Modification description for:

XLX2000 G2

XLX2000 G3

XLX2000 G2 (SBS48) => XLX2000 G3

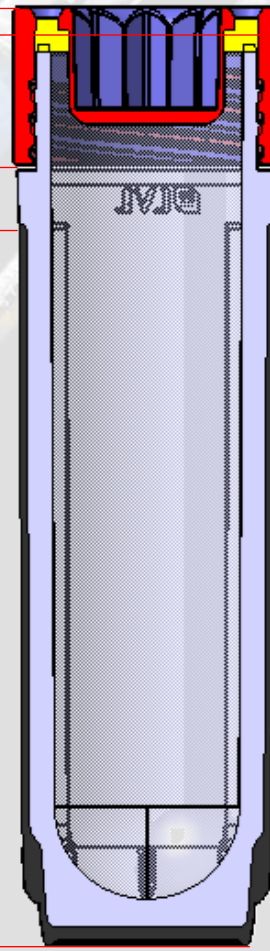
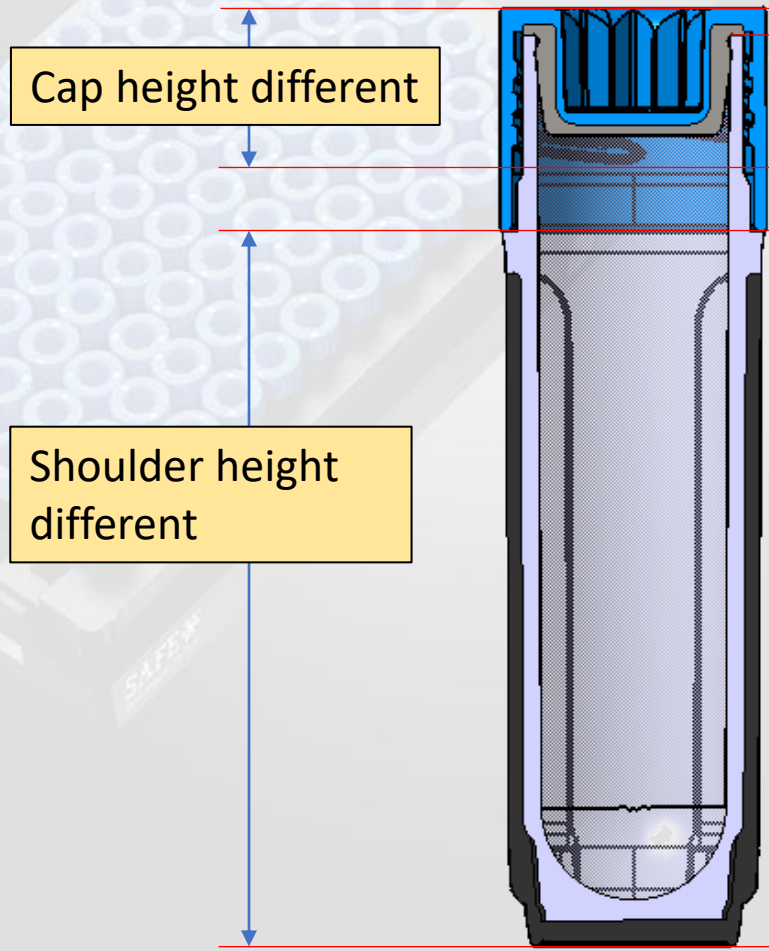
Overall height identical

Working volume identical

Volume bottom point identical

Tube height without cap at G3 is 0,5mm smaller than at G2

➔ No problem for switching from G2 to G3

XLX2000 G2 (SBS48) => XLX2000 G3

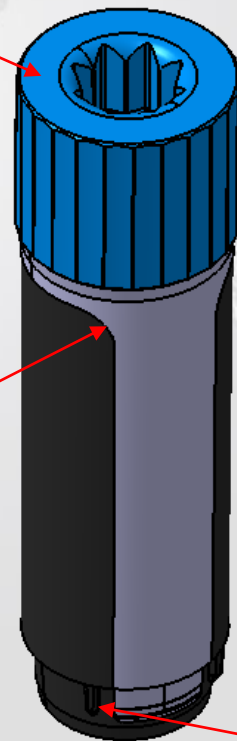
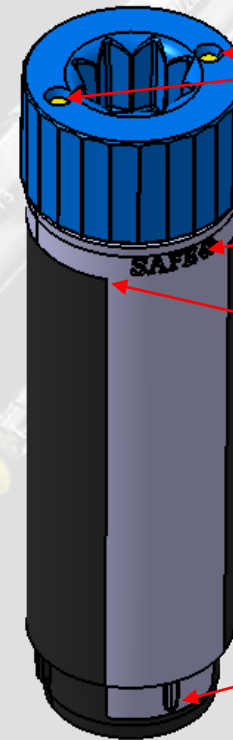
No dots on top of cap

Rounded ends of black component

Torsional securit 4x 90° with 4 in black area

2 dots on the top of the cap

Engraved logos on tube

Sharp corner ends of black component

Torsional securit 4x 90° with 2 in transparent area
